Physical Education Project (Phase 1, 2)

*Draft Subsequent Project EIR to
2015 Facilities Master Plan Update and Physical Education
Projects Final Program/Project EIR (SCH 2002041161)*

Response to Comments

Volume 4: Appendices

FIGURE 4
 Project Trip Distribution

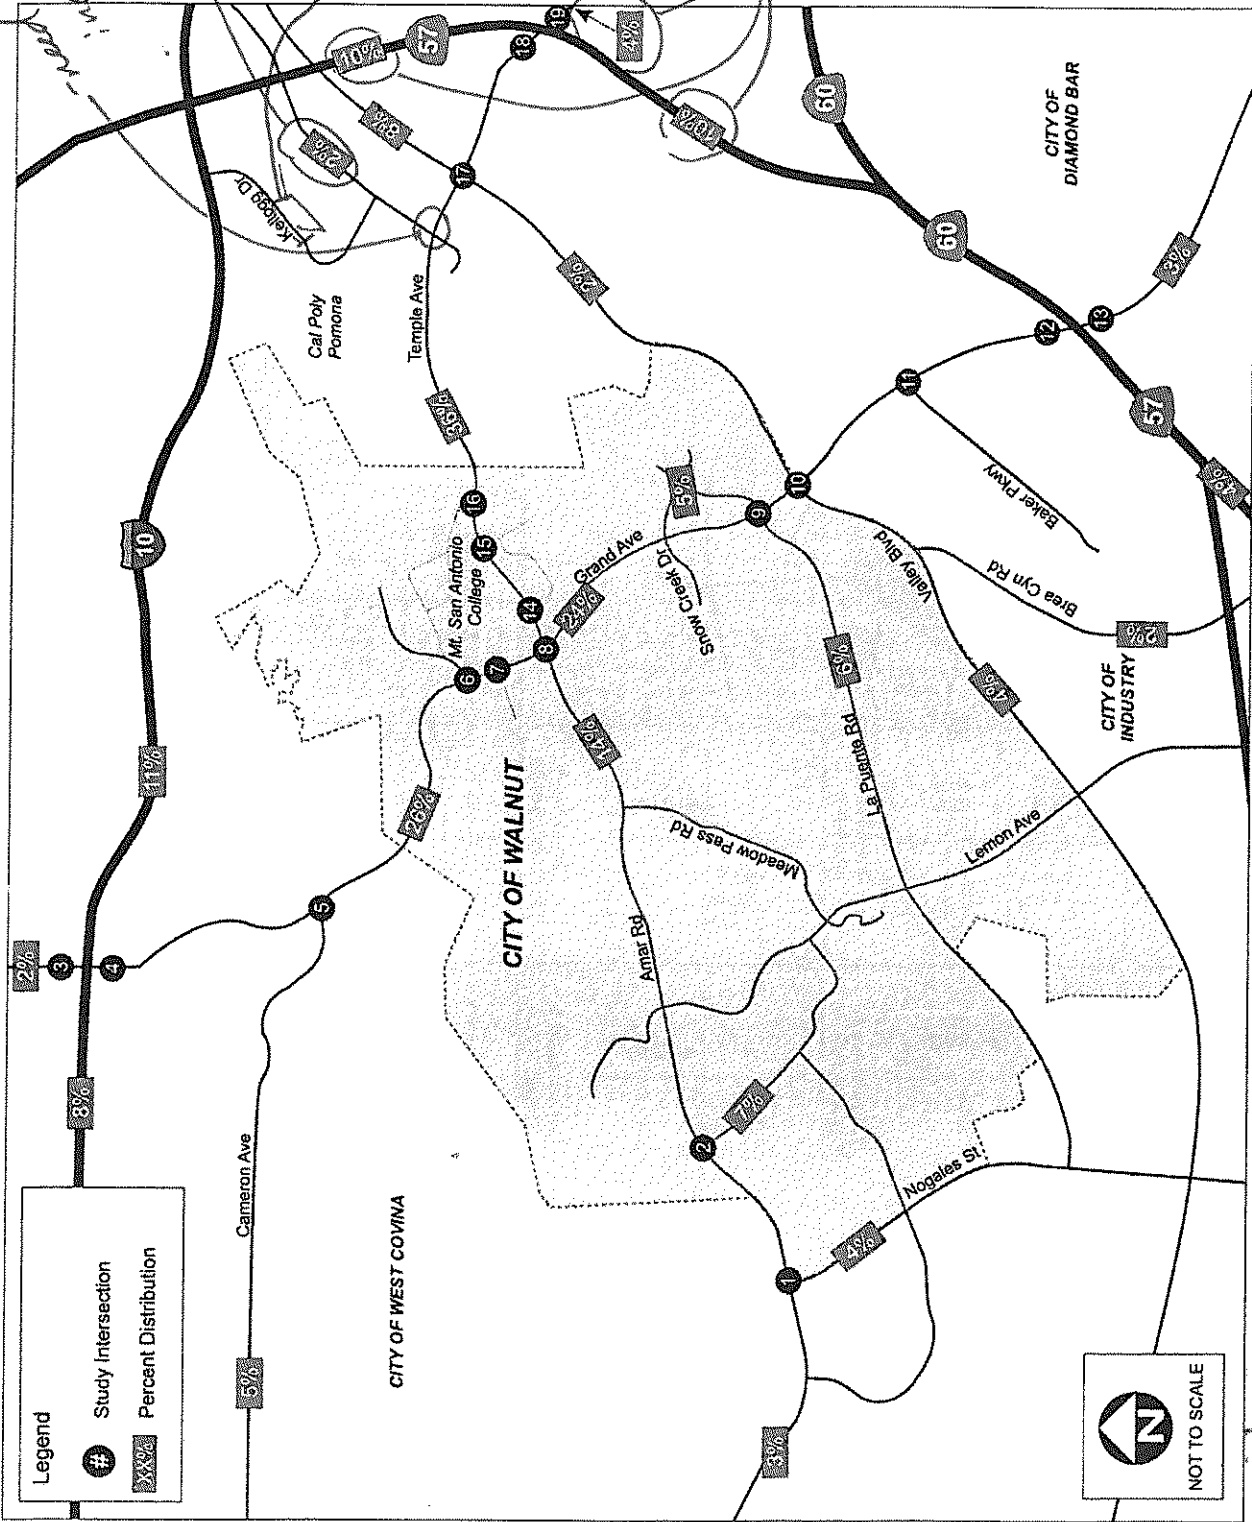
This letter is in response to the Draft EIR for the Mr. San Antonio College 2015 Facilities Master Plan Update and Physical Education Projects SEIR. The City of Pomona would request that the traffic study include the following as outlined on Figure 4 Project Trip Distribution:

- 1) Should include the intersection of South Campus and Temple Avenue as a study intersection.
- 2) Include a percentage of traffic associated with Kellogg Drive as a high percentage of vehicles come exit 10 Fwy eastbound and continue to Kellogg Dr.
- 3) South Campus volume percentage distribution appears to be too low and not realistic.
- 4) Provide data or methodology to justify the percentage trip distribution along 57 Fwy of 10 percent northbound and 10 percent southbound.
- 5) Justify 4 percent distribution from Temple Ave east of 57 Fwy.
